STAFF REPORT: 6/14/2023 REGULAR MEETING

APPLICATION NUMBER: #23-8396

ADDRESS: 2405 BURNS

SCOPE: REPLACE VINYL WITH WOOD WINDOWS; REPLACE FENCE; REMOVE PAINT; REPAIR CHIMNEY, PORCH STEPS, AND FRONT WALKWAY (WORK COMPLETED WITHOUT APPROVAL)

Figure 1, by Applicant: (Northeast) side elevation, picture windows #3 and #6, and replaced vinyl window #7.

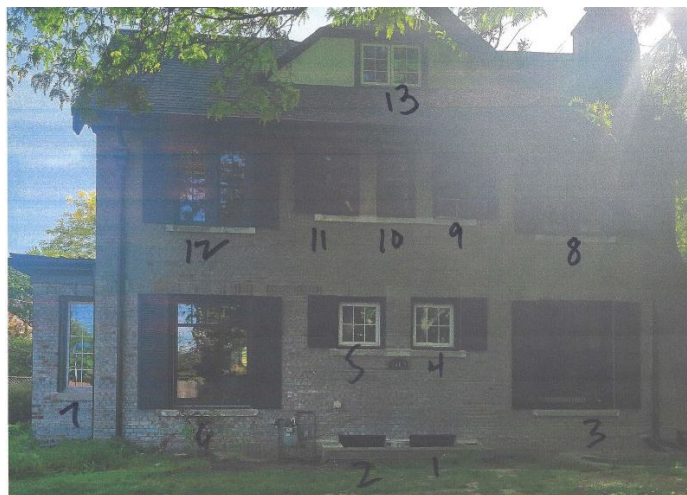
- Some windows do not appear to be restored original windows, while others may be. For example, the applicant states the two picture windows of the first floor, southeast elevation (ie. windows 3&6) were "found in the garage, stripped, repaired, and reglazed" to replace the vinyl windows that were present. These windows, in staff's observation, appear to be newly constructed wood windows with modern insulated glass. They are of a design, operation and configuration that do not appear to be historic. The designation slides and other preceding images do not show the original windows either. Because at these window locations the configuration of the windows is unknown, staff has the opinion that the application shows *incompatible* solutions because they do not meet the following minimum conditions:

- The operation of the windows are fixed, rather than double hung, and do not provide ventilation, which would be a distinctive historic function of these windows.
- The design language of this house has ribbons of double hung windows in sets of at least two with muntins to divide the individual sashes. These picture windows introduce a new scale and design that is not likely to occur for this type of architecture.
- The configuration of the picture window conveys a new style that calls attention to itself rather than blending in and being compatible with the 6/1 or 4/1 configuration of the adjacent original wood windows.

- The same observation for windows #3 and #6 also applies to newly installed window #7, and its pairing (between windows #16 & #17) on the opposite side of the bay. This appears to be a newly constructed, fixed picture window. Similar to the concerns raised previously, it appears that the intention is to continue this pattern across the front elevation of the house, windows #16. (See site photo #5, and figures 1&2). The applicant states that no work was being done on window #7 in their application, but this window, and windows #4 & #5 and the one next to #16 facing the porch, were replaced during the application process. (See Site photos 2&5).

- The configuration of the divided light does not match the 4/1 or 6/1 pattern of the other original windows.
 - The absence of a muntin between two windows to create a single picture window for windows #3 & #6 breaks up the continuity of the window pattern, particularly with how the muntins would like align tie the first and second floors together.
